RE: Des. No. 0400991, Additional Information (A.I.) Evaluation for  
Segment 1, State Road 25 Hoosier Heartland Highway Project,  
Tippecanoe County, Indiana

S.R. 25 HOOSIER HEARTLAND HIGHWAY  
ORIGINAL INTERSECTION OPTION

# S.R.25 HOOSIER HEARTLAND HIGHWAY NEW ROUNDABOUT OPTION

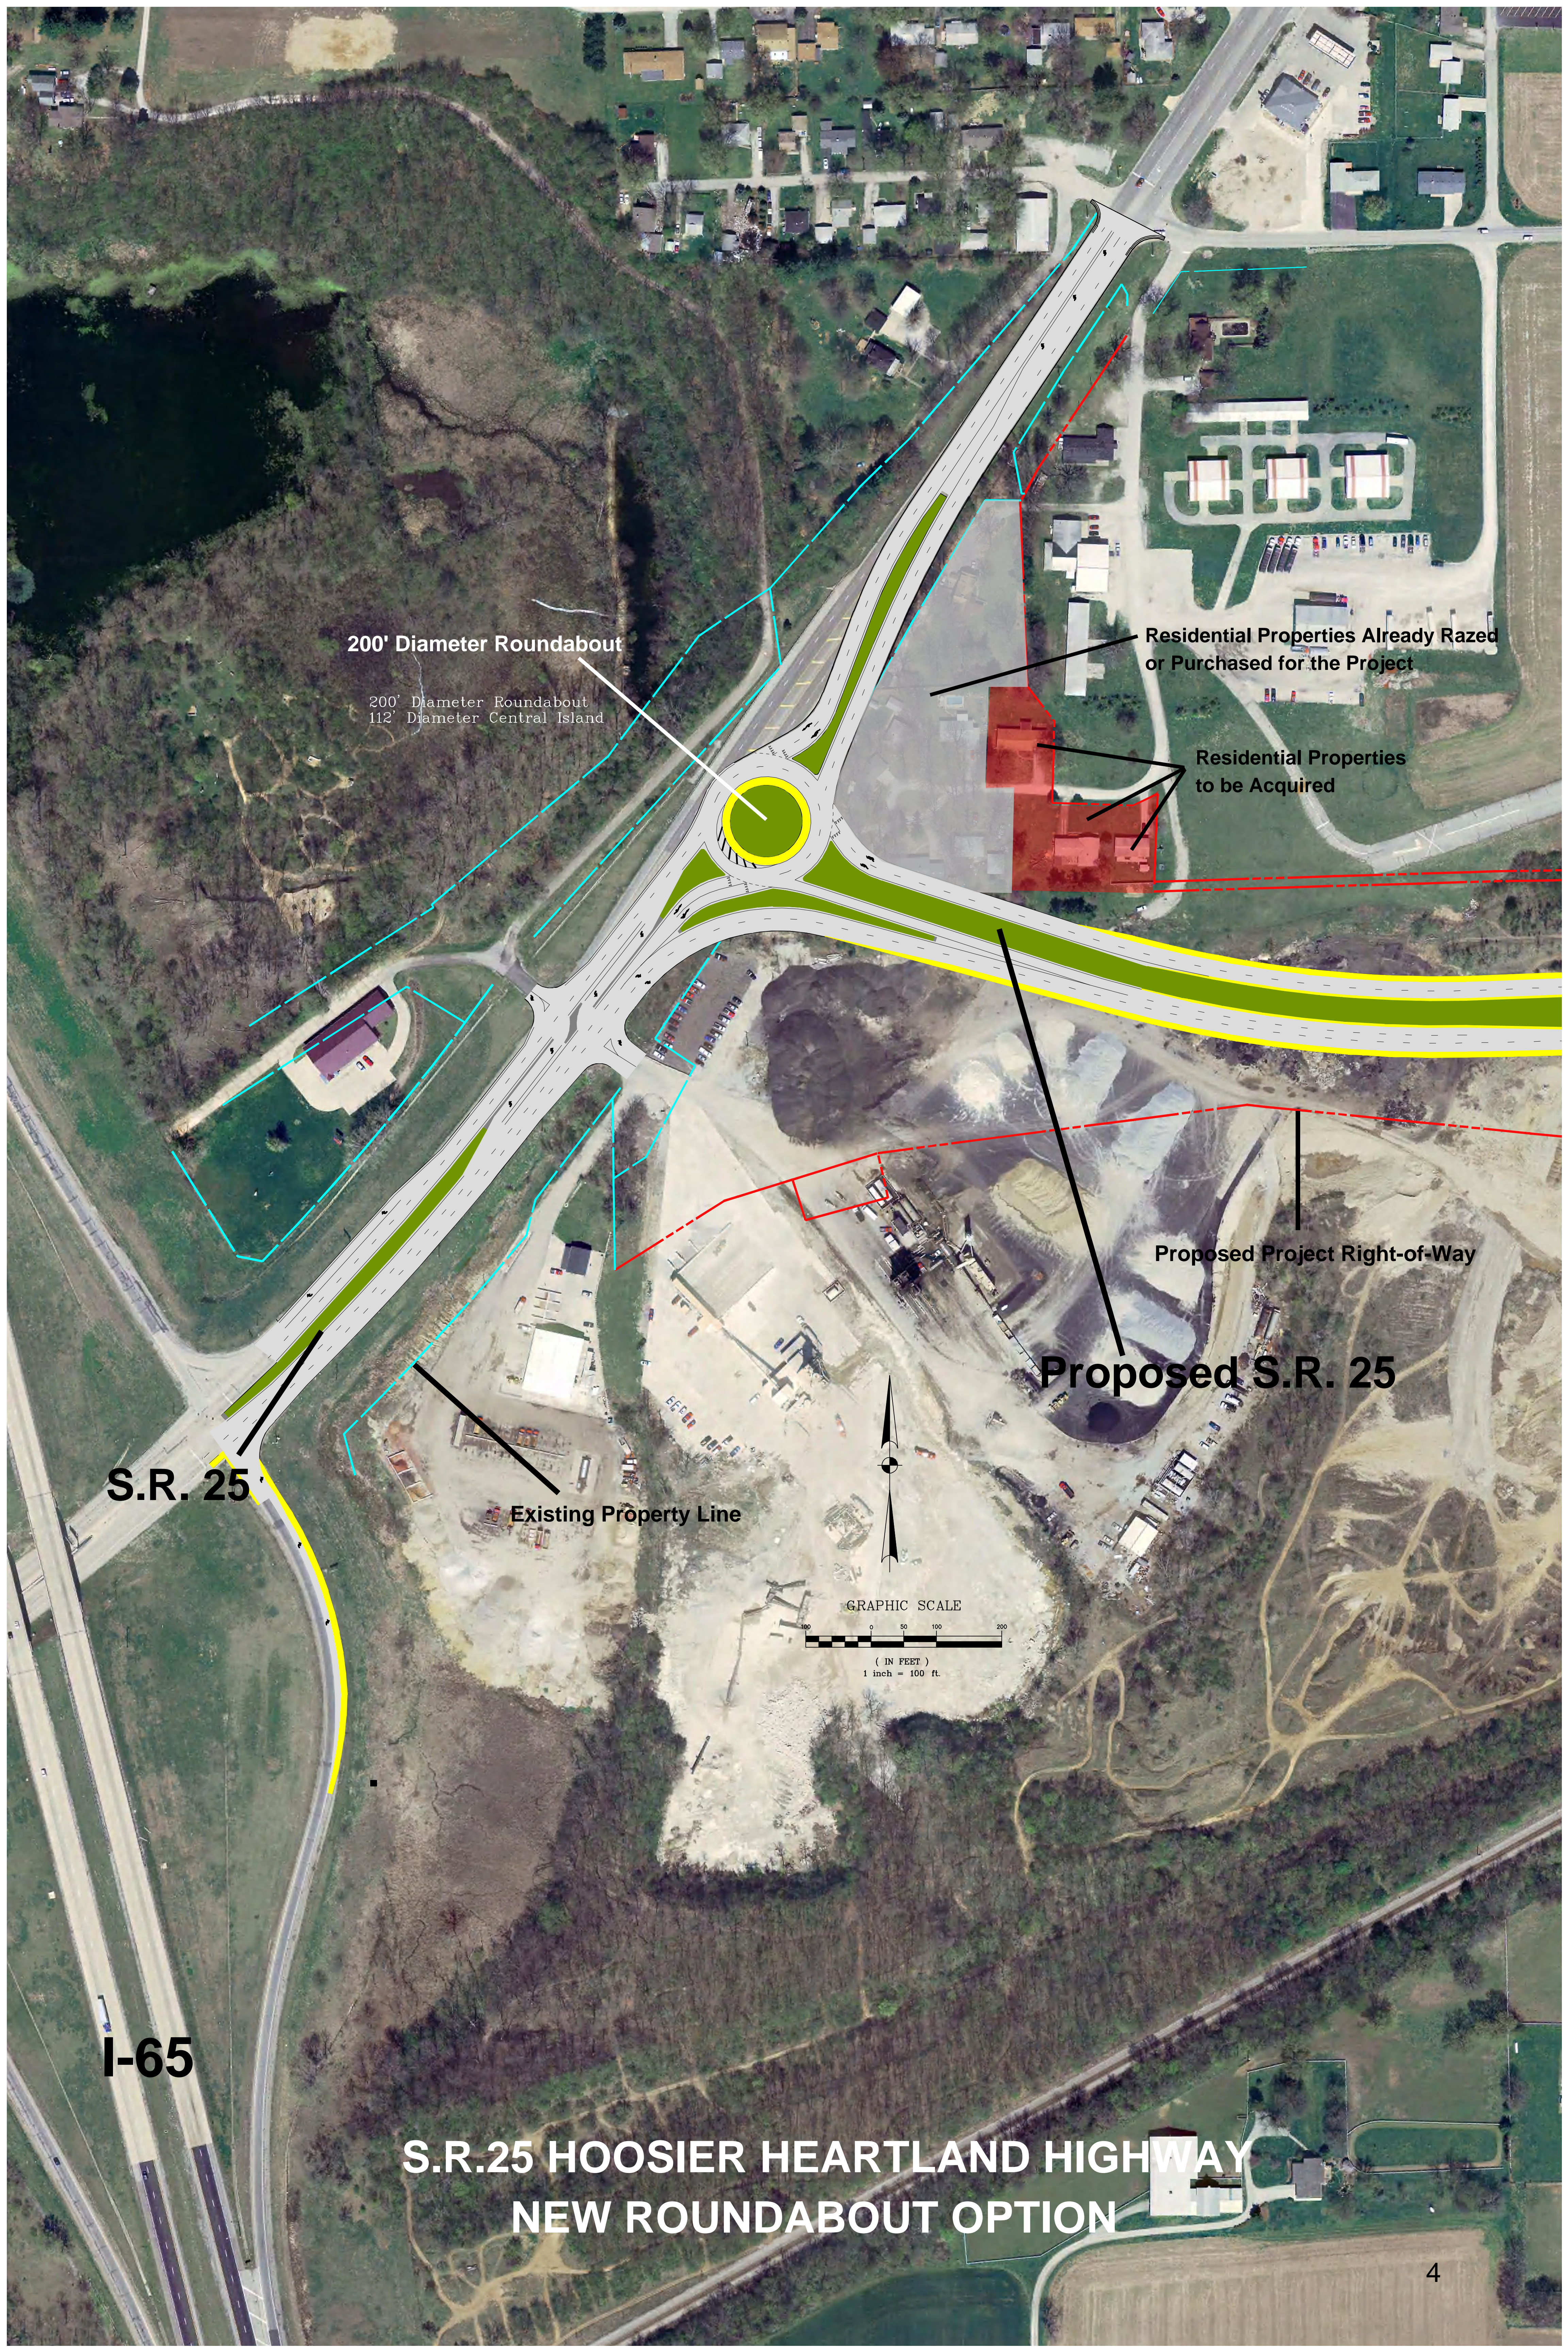
1. We believe the roundabout should be 2 lanes all around (except on the south side where you have designed the slip lane) to accommodate the significant number of trucks using the roundabout.

2. Are all the turning radii large enough for double-trailer semis? Also, should we be planning for triple-trailer semis? I see more and more on the interstates these days. What is Indiana's position about the use of triple-trailer semis?

3. The lighting you discuss is critical to minimize confusion and reduce crashes.
4. Given that this is a gateway to the community, we'd ask that the center of the roundabout at least be grass (not paved or gravel). Landscaping would be nice, but I won't push my luck.

5. There should be LA R/W from the I65 ramps all the way through the roundabout, except at the IMI and BP driveways.
6. We have some safety concerns about the proposed access at IMI/Fox and BP. Left turns out of the BP will be more difficult because with the roundabout there will be no platooning created for southbound traffic. Left turns in can still be accommodated and their situation improved over the current right in – right out only design. We also recommend left turn in only for the IMI/Fox access. Trucks trying to turn left out of the IMI/Fox access will not be able to see the traffic coming from the north until vehicles are nearly through the roundabout. Slow moving trucks will have difficulty avoiding vehicles accelerating out of the end of the roundabout – it looks like there is about 400' from the end of the roundabout to the IMI/Fox access. If the access is designed without the left out movement, trucks can safely turn right, go up to the roundabout and around to head back into Lafayette or get on I65. It would be equivalent to a legal U-turn. We propose that both BP and IMI/Fox have right in – right out – left in
